Access Compliance Report

Public Rights-of-Way (Curb Ramps)

Intersection ID: 10040544	Main Street: W_6TH_ST	Cross Street: N/A	Location: NW
ADA ID: CCDCEC93AFB6	Ramp Type: ParaDiag	Initial Pass/Fail: Fail	Overall Compliance: No
Codes/Mitigation Info/Possible Solution		Field Measurements/Component Compliance	
Severity Score: 25

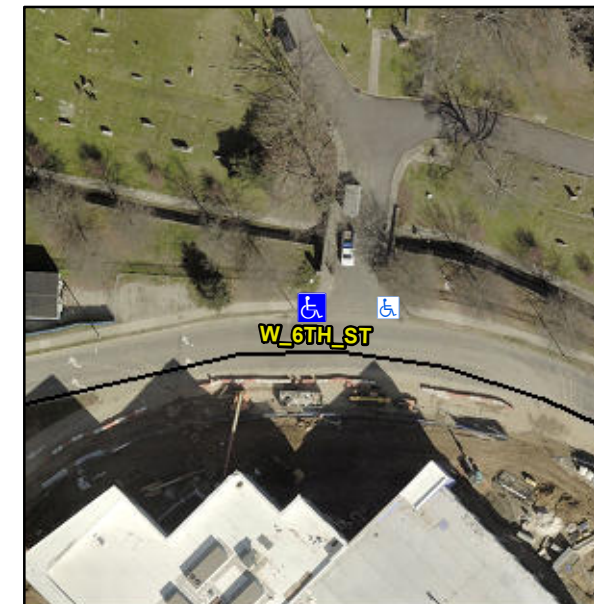
R304.3.2, R304.5.3

Compliance	Description	Data	Compliance	Description	Data
N/A	Ramp Length LT (in)	54.0	N/A	Ramp Length RT (in)	60.0
Yes	Ramp Width LT (in)	70.0	Yes	Ramp Width RT (in)	62.0
Yes	Ramp Slope LT (%)	5.6	No	Ramp Slope RT (%)	10.6
Yes	Ramp XSlope LT (%)	1.4	No	Ramp XSlope RT (%)	5.5
N/A	Landing Length (in)	N/A	N/A	DWS Provided?	N/A
N/A	Landing Width (in)	N/A	N/A	DWS Contrast?	N/A
N/A	Landing Slope (%)	N/A	N/A	DWS Length (in)	N/A
N/A	Landing X Slope (%)	N/A	N/A	DWS Full Width?	N/A
N/A	Landing Curb? (Y/N)	N/A	N/A	DWS Offset (in)	N/A
N/A	Shared Landing?	N/A			
N/A	Gutter Ponding?	N/A	N/A	Gutter Slope (%)	N/A
N/A	Gutter Lip Ht (in)	N/A	N/A	Gutter X Slope (%)	N/A
N/A	Painted X Walk1?	No	N/A	Painted X Walk2?	No
	X Walk 1 Direction	To S		X Walk 2 Direction	To E
N/A	X Walk 1 Width (in)	N/A	N/A	X Walk 2 Width (in)	N/A
	X Walk 1 Slope (%)	8.0		X Walk 2 Slope (%)	5.2
	X Walk 1 X Slope (%)	4.5		X Walk 2 X Slope (%)	1.8
N/A	Ramp inside XWalk1?	N/A	N/A	Ramp inside XWalk2?	N/A

Road Slope (%)	2.5	N/A	Clear Space?	N/A
	Road X Slope (%)	8.0	N/A	Clear Space to XWalk (in)	N/A
N/A	Any Obstructions?	N/A	N/A	Storm Grate/Utility Hazard?	N/A
	Obstruction Type			Storm Grate/Utility Type	
		N/A			N/A
			Yes	Surface Condition? (G/P)	Good
			N/A	Curb Slope (%)	9.8

Remove & Replace Curb Ramp With Two New Directional Ramps or Equivalent.
